ADDENDUM NO. TWO (2)
TOWN OF BRASELTON, GEORGIA
2026 GROUNDWATER EXPANSION AND DISTRIBUTION STORAGE
ISSUED JANUARY 23, 2026

RE: 2026 GROUNDWATER EXPANSION AND DISTRIBUTION STORAGE
EMI PROJECT No. 18-021

The purpose of this Addendum is to provide the omitted storage tank drawings, existing contours for treatment site, the pre-bid meeting attendance, and add Precon Corporation as a pre-approved concrete storage tank manufacturer. The following items of the Contract Documents are modified as part of this Addendum:

ISOMETRIC

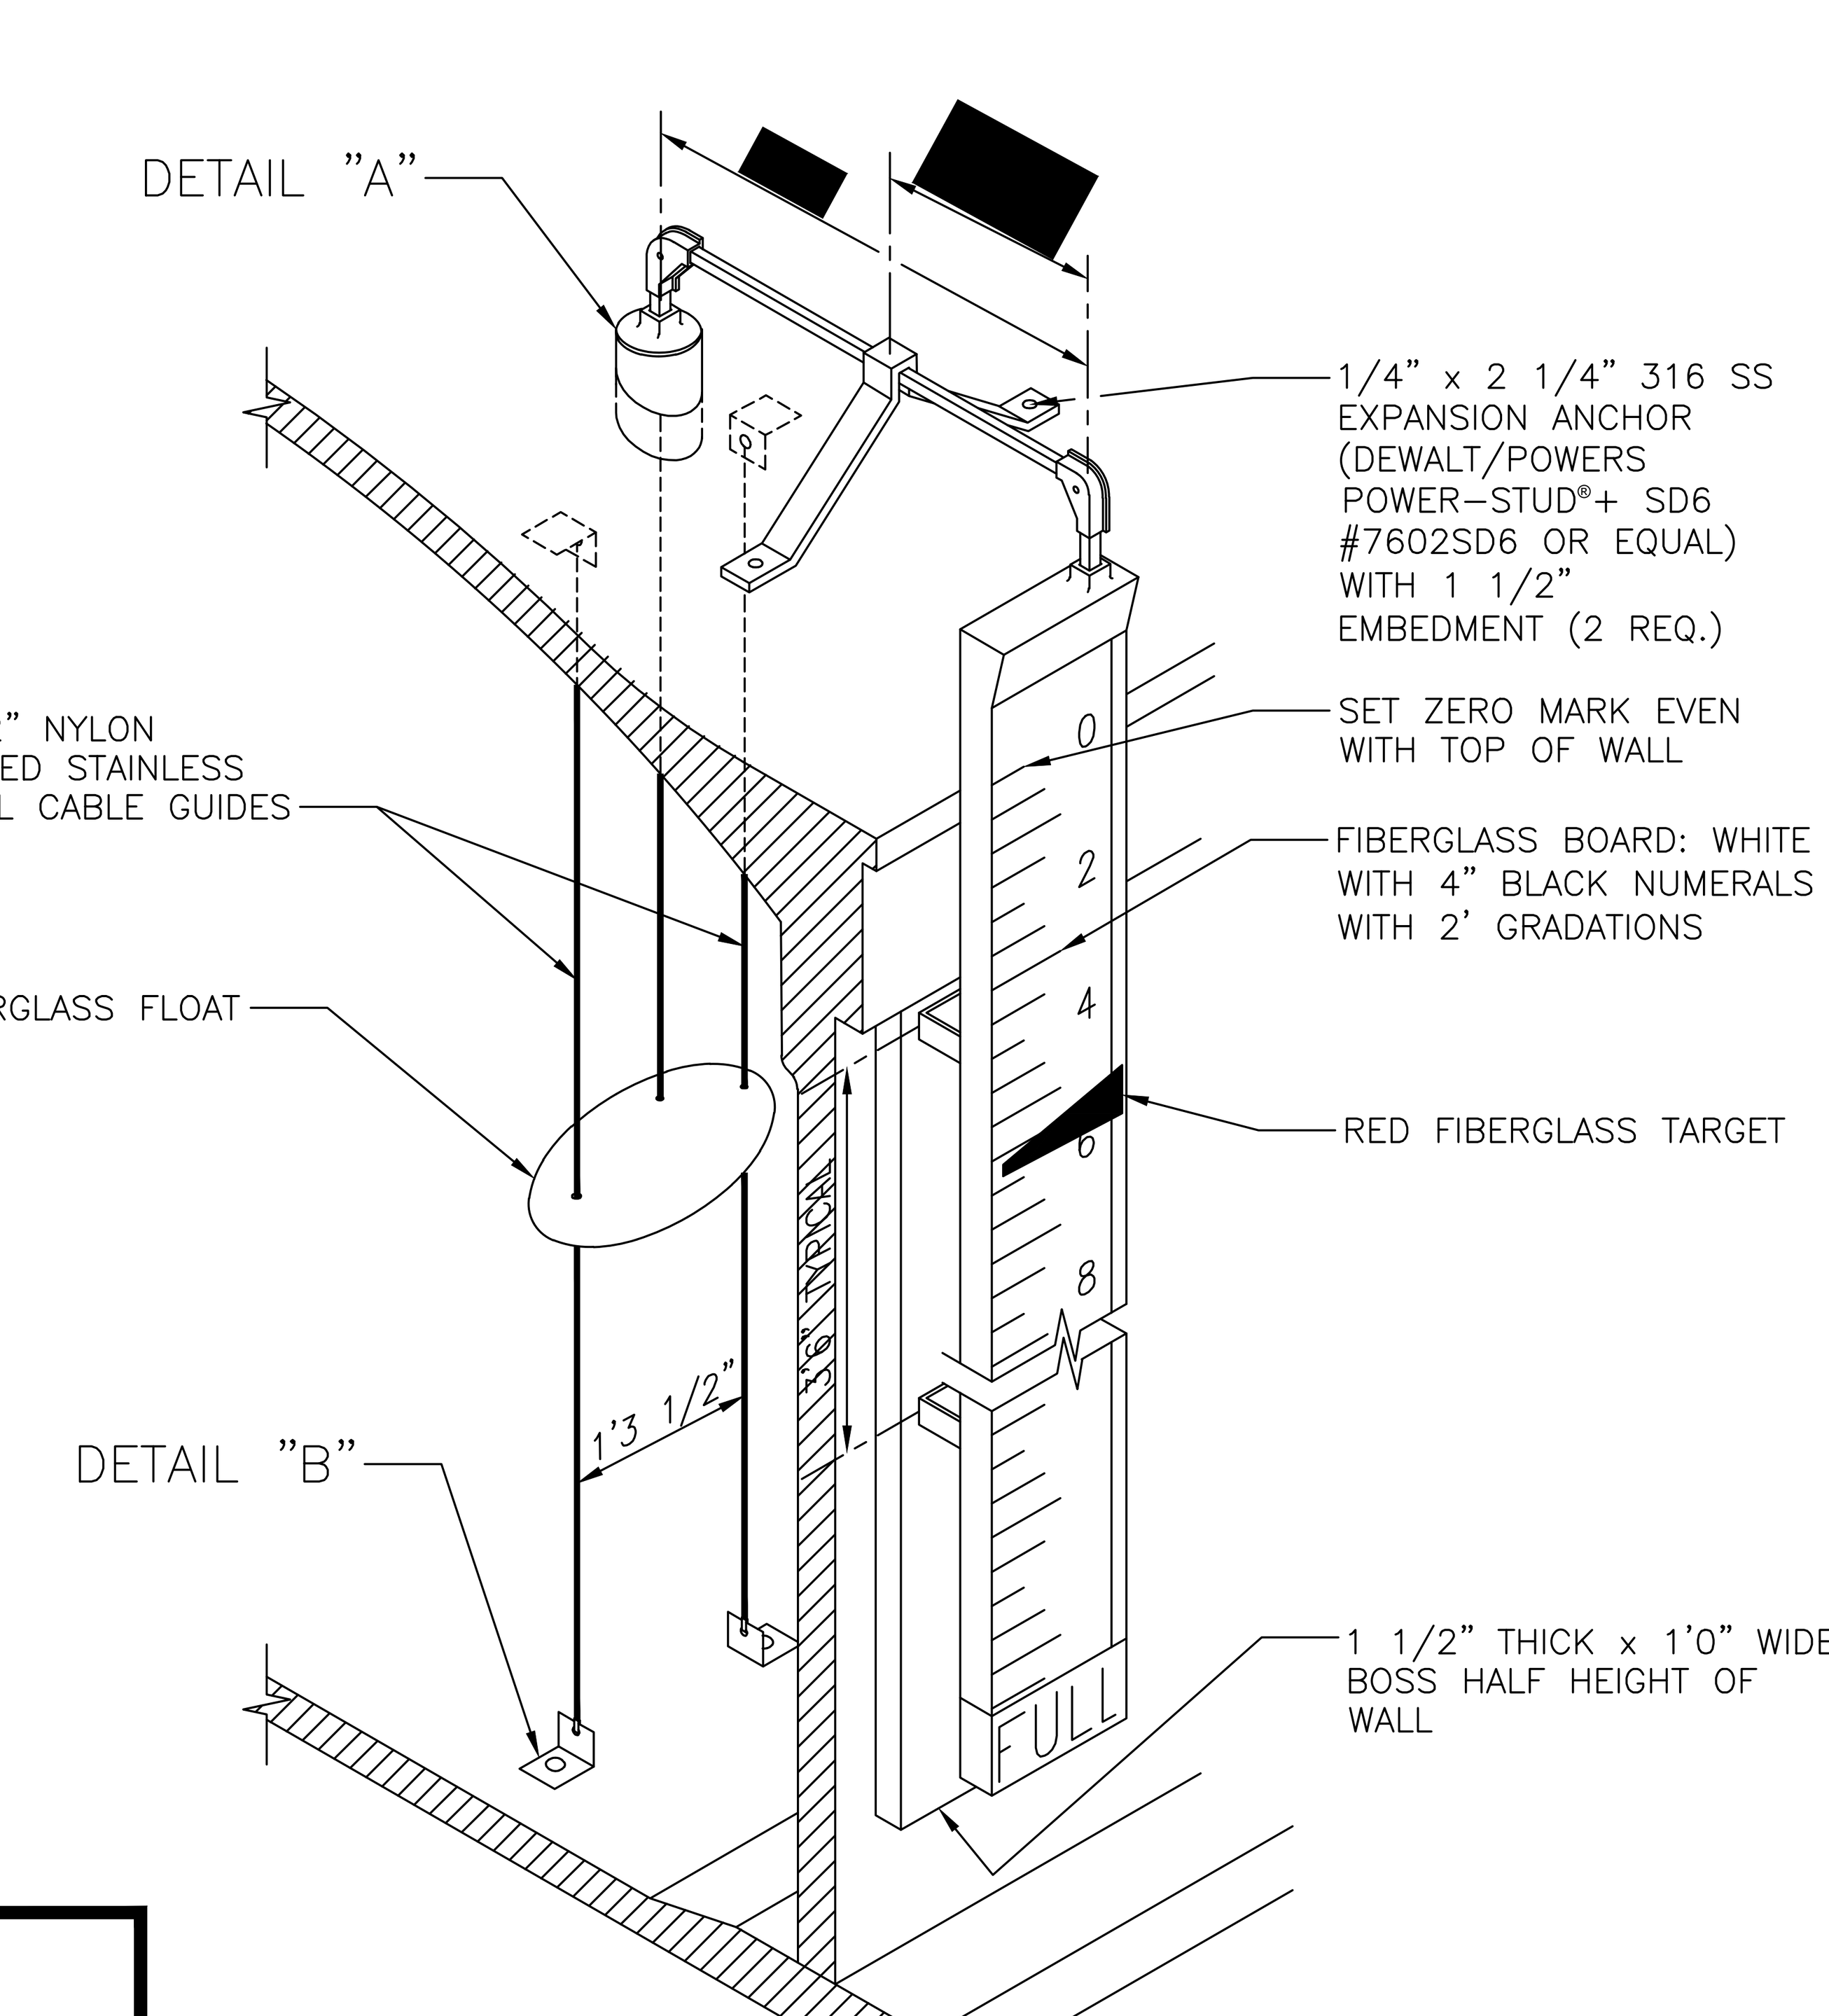
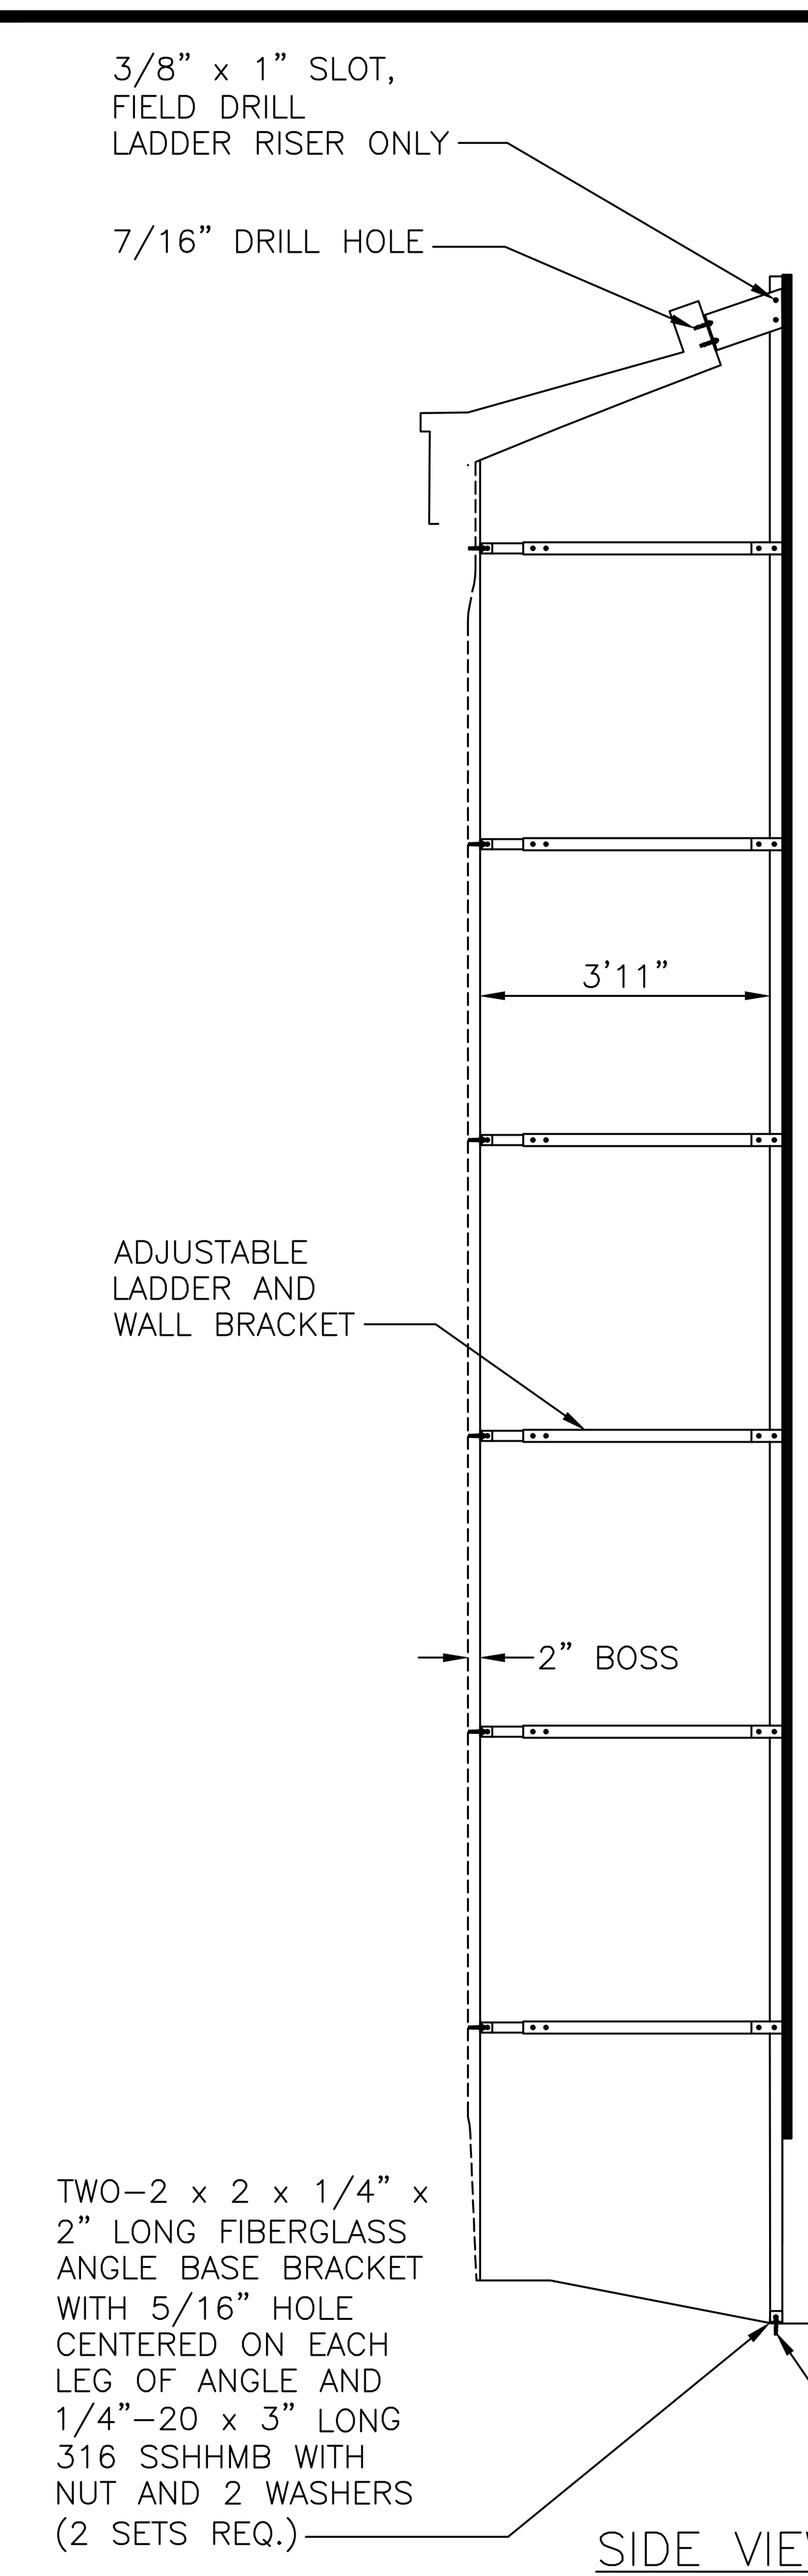
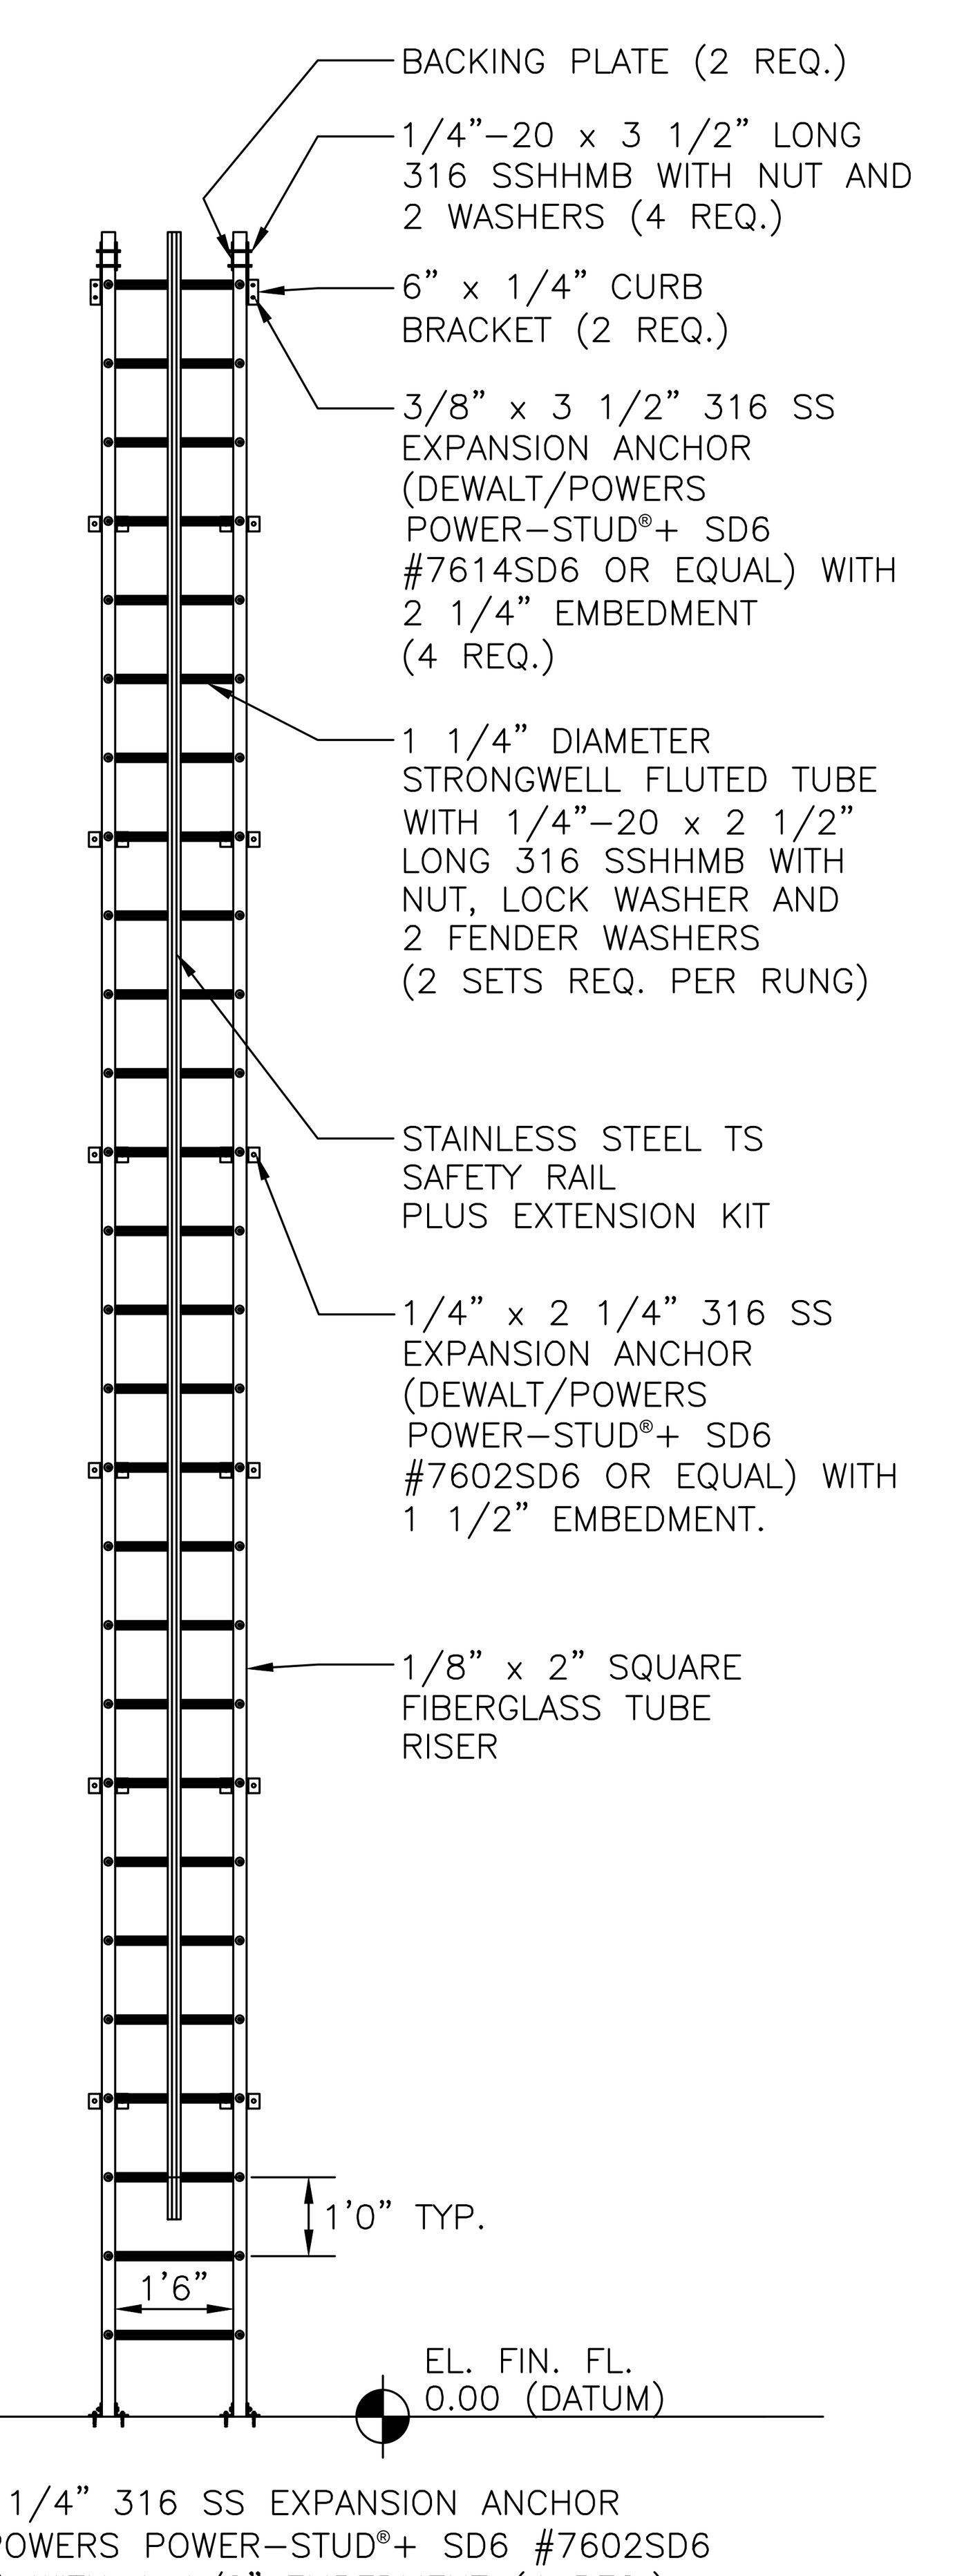
1. The contract documents appear to be missing plan sheets M7-M10 for the new tank listed in the sheet index. Can you please provide the missing drawings?

- <u>*Plan sheets M7-M10 have been provided to show plans for the concrete storage tank. See attached plan sheets.*</u>

EMI Response: Sheets M7-M10 were omitted in error. Please see the original sheets attached to this addendum.
